**ADDENDUM NO. 1**

PROJECT: West Rutland Sidewalk Segments - STP BP15(1)  
BID DUE DATE: **Tuesday, November 12, 2019 at 2:00 PM**  
FROM: David Conger, DuBois & King Project Manager

**BOLLARD AND STOP BAR LAYOUT**

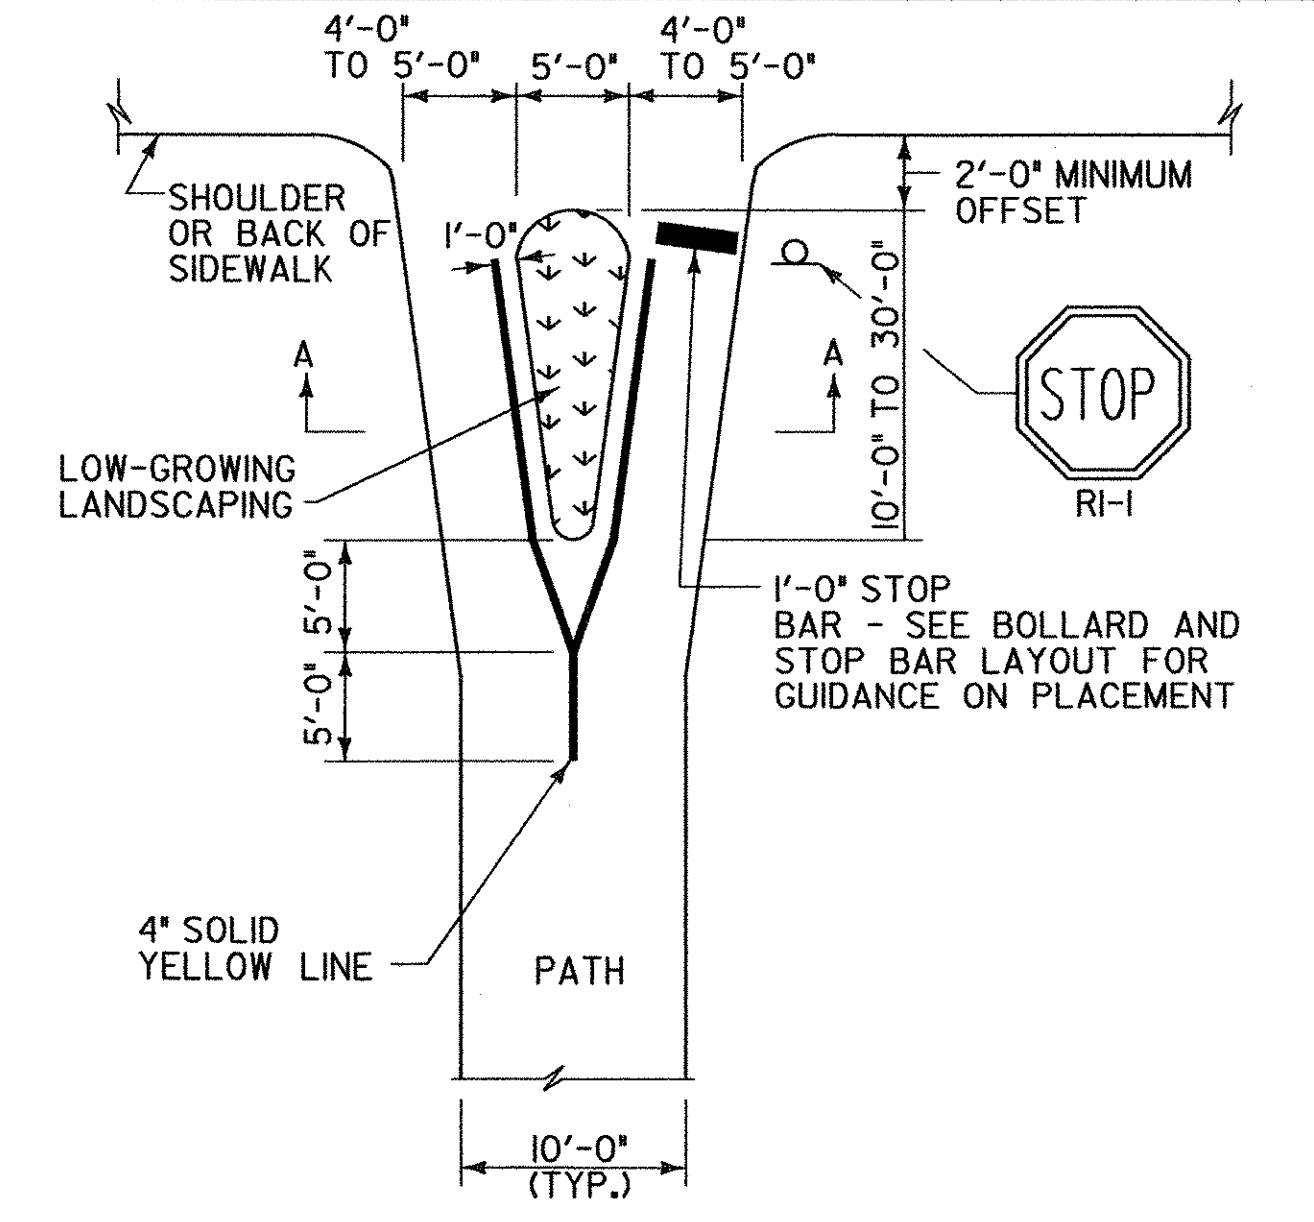
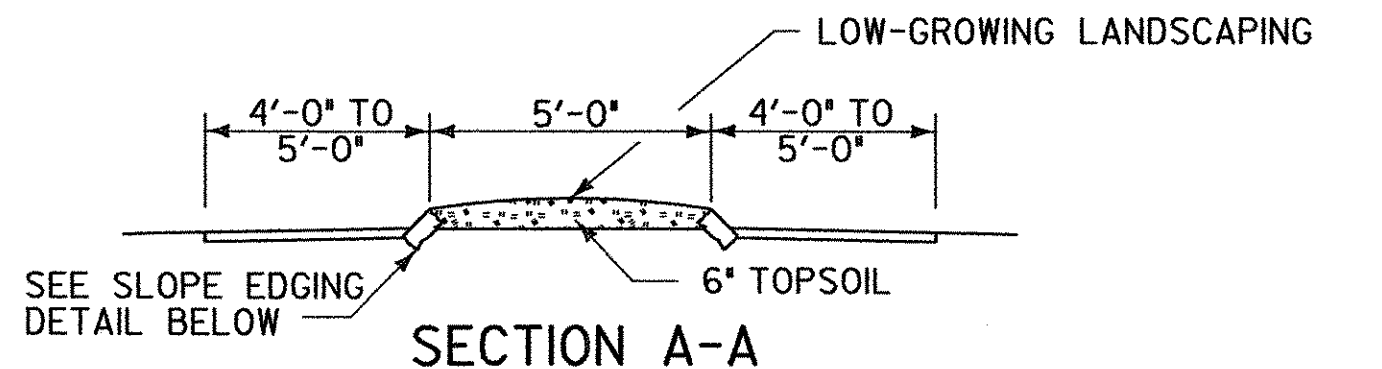
Add “Shared Use Path/Highway Intersection Details” Standard A-80 dated 03-31-2004 to VAOT Standards list. (See attached)
- 2) Sheet 56 – WRS-2.1 High School Site Plan & Profile 1

**STEEL BOLLARD**  
 THIS SHEET IS NOT TO SCALE

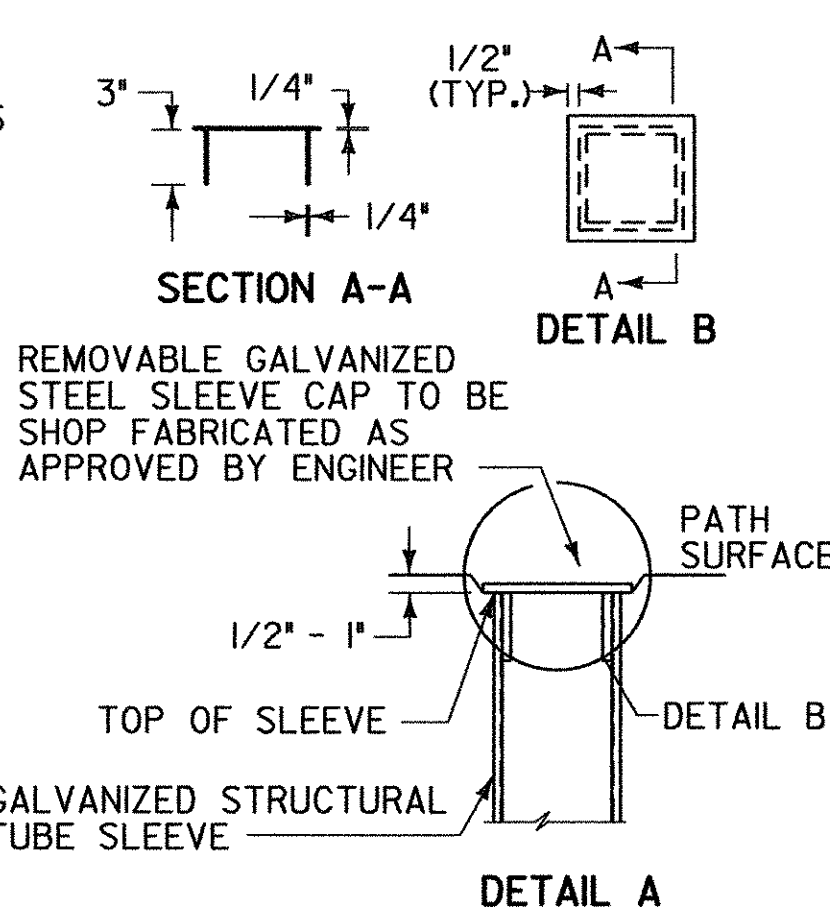
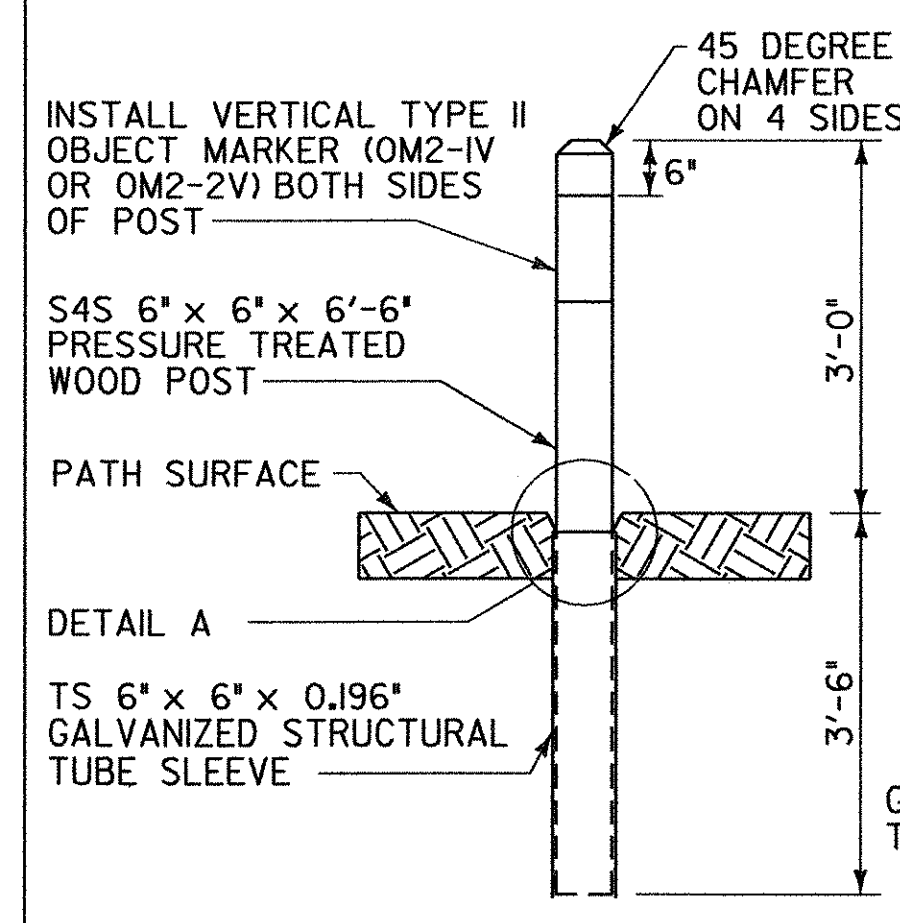
Installation of a bollard at STA 0+70 centered on bituminous asphalt path (See Detail Attached) shall be added.
- 3) Sheet 57 – WRS-2.2 High School Site Plan & Profile 2

Installation of a bollard at STA 6+70 centered on bituminous asphalt path (See Detail Attached) shall be added.
